CITY OF NAPOLEON - BUILDING DEPARTMENT

Permit No. 672-77 Issued 3/23/77
date

RESIDENTIAL PLAN CORRECTION SHEET

ADDENDUM to Permit No. 672-77
 Owner H. BOSTELMAN
 Location 845 DAGGETT

DISAPPROVED 3/14/77 T.W.T.

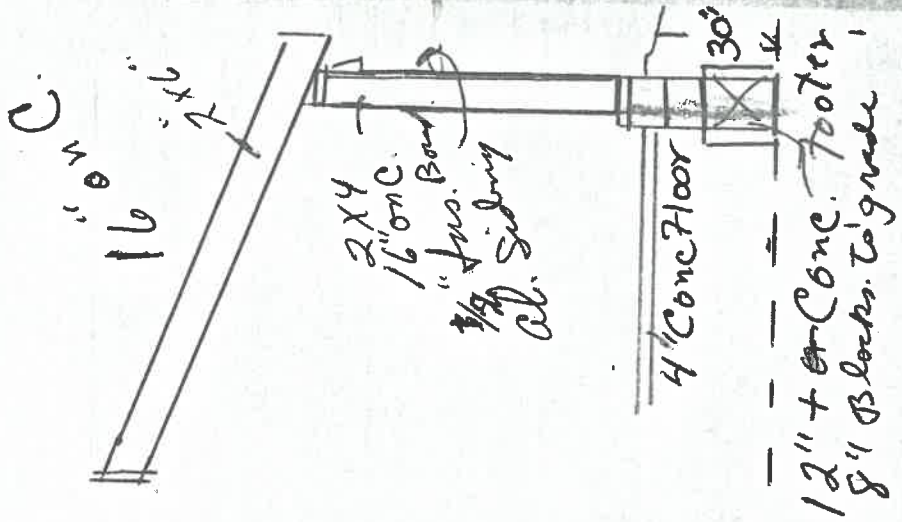
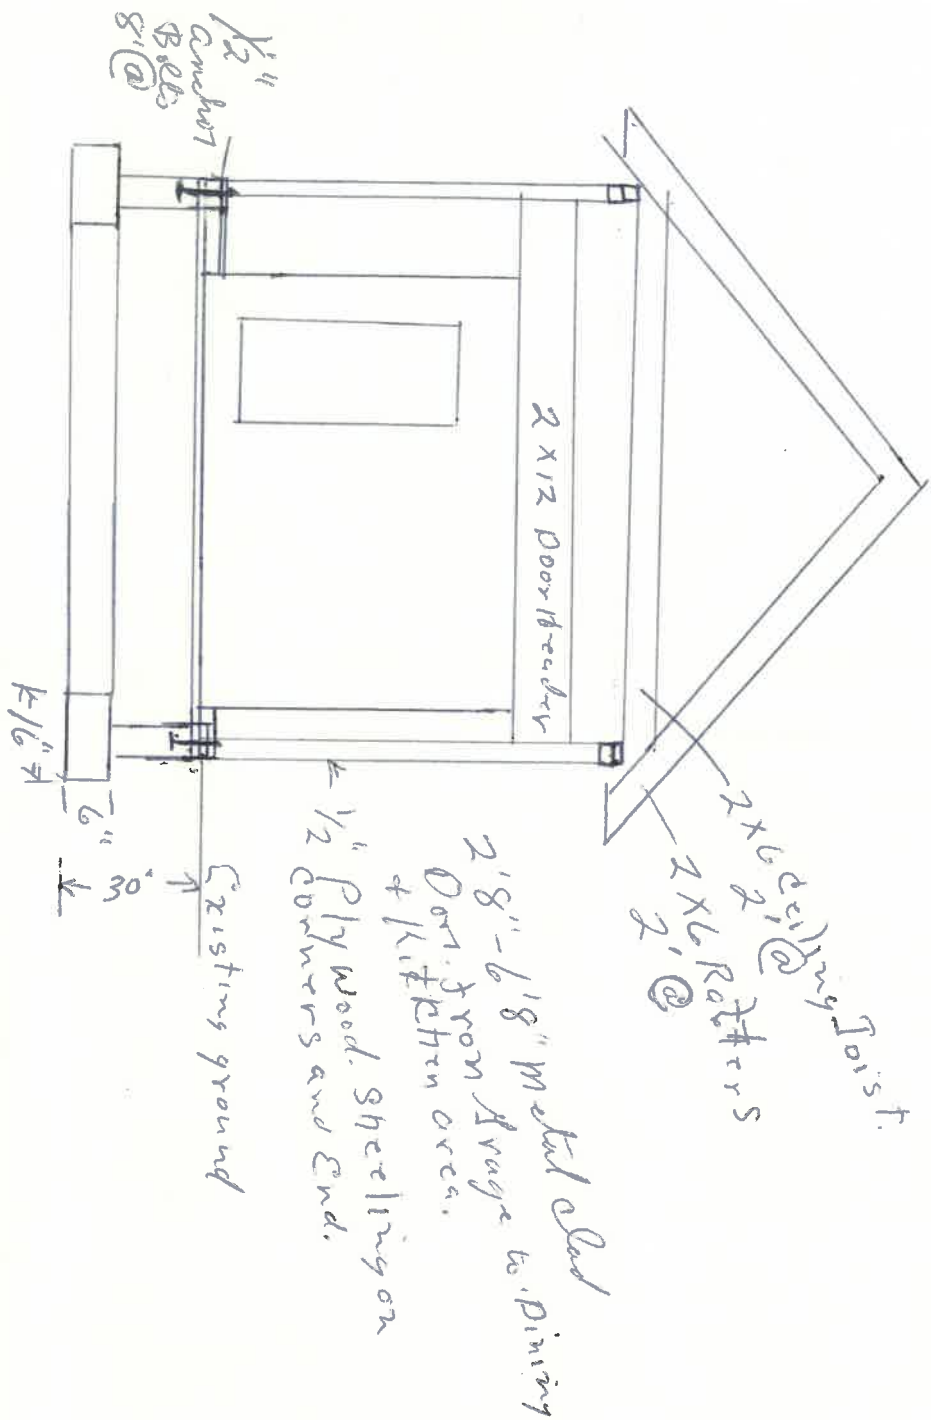
ADDITIONAL CORRECTIONS: ANY OPENINGS (WINDOW) BETWEEN THE EXISTING HOUSE & THE PROPOSED GARAGE SHALL BE ENCLOSED WITH A 1 HR. FIRE RATED MATERIAL
